**MEETING AGENDA  
Thursday, January 27, 2022**

**Public Hearing (cont'd): Notice of Intent (NOI)** – Willow Road and Route 2A, Massachusetts Department of Transportation-Highway Division (MassDOT), Danielle Spicer, MassDEP File # 100-0477, Assessor's Map 30

This memorandum provides the responses to the Conservation Commissions comments during the Con Com hearing on 12/16/2021 and during the Site Walk on 12/18/2021 for the roadway improvements along Route 2A in Littleton, MA (DEP File No. 100-0477). The Con Com's comments are copied below in *italics*. Responses to each comment are noted below in **Bold**.

Photo 1 – Downstream Side of Culvert at Bennetts Brook

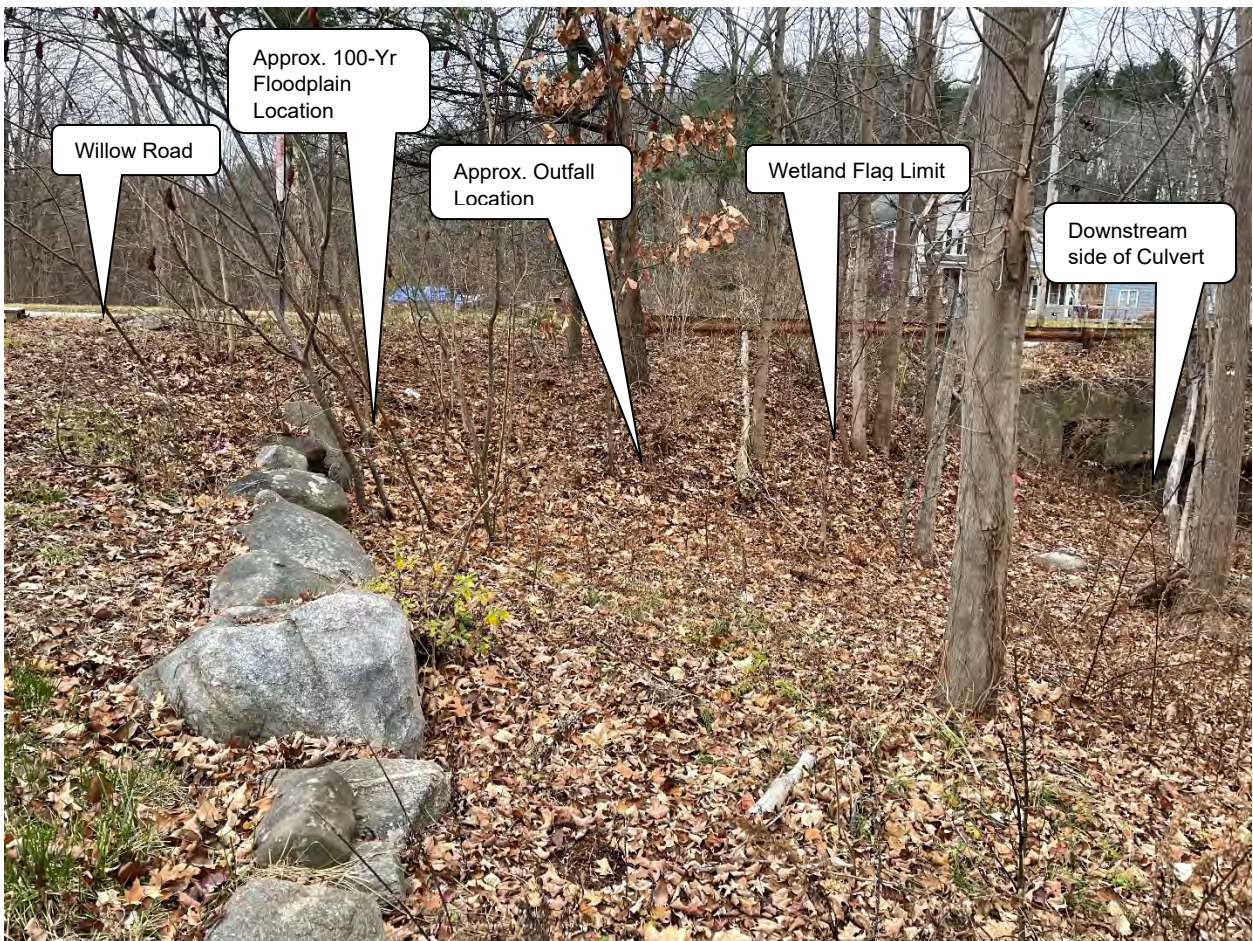
3. *Can additional treatment be done at the outfall? If not, can additional treatment be done along Willow Road.*

The outlet along the downstream Brook is immediately adjacent to the Riverfront bank, wetlands and Floodway and located within the 100-year Floodplain (see photo 1 below). Stormwater Mitigation cannot be done within the Floodway, wetlands or below the Riverfront Bank per 310 CMR 10.58 (4)(d). The majority of the upload area is located within the 100-year Floodplain and has an established vegetated slope, which is not ideal to disturb for stormwater mitigation. The outlet elevation of the drain line is at approx. elev. 240, while the adjacent road and parking area is around elevation 244', which would require a 4' cut adjacent to the parking lot, removal of trees and installation of a retaining wall to install a stormwater BMP. Due to the close proximity to the Brook, groundwater will be high, so infiltration will not be feasible. Given these site constraints, and that removal of an established vegetated Riverfront Area contradicts the performance standards within the Wetlands Protection Act, we do not recommend a Stormwater BMP in this location.
